AIRWORTHINESS DIRECTIVE

Beechcraft 1900 Series Aeroplanes**AD/BEECH 1900/41****Elevator Trim System****13/2003
DM**

Applicability: All Models 1900, 1900C, and 1900D aircraft.

Figure 1

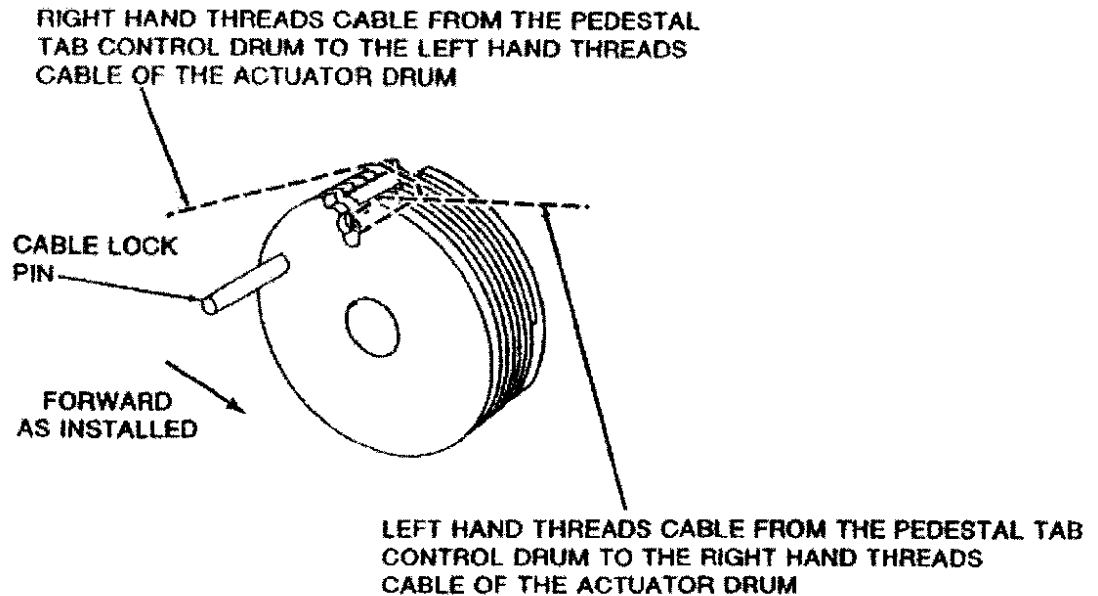
- Requirement:**
1. Mark with a pen, the applicable figure in the maintenance manual as referenced below. The depiction in the referenced figures is incorrect for the elevator trim drum only, and depicts the cable drum at 180 degrees from the installed position and shows the open, keyed side of the drum instead of the flat side of the drum. Insert corrected figure (Figure 1 of this Directive) into the applicable maintenance manual, and identify it accordingly, as specified in Raytheon Safety Communique No. 234, dated September 2003:

- a. Figure 9 of Chapter 27-10-00 of the Model 1900/1900C Airliner Maintenance Manual (114-590021-7B). Clearly note in pen that existing portion of Figure 9 is correct for the aileron trim drum only and insert corrected figure (Figure 1 of this Directive) marked in pen as correct for the elevator trim drum only; or,

- b. Mark out Figure 201 of Chapter 27-30-04 of the Model 1900D Airliner Maintenance Manual 125-590000-15). Insert corrected figure (Figure 1 of this Directive).
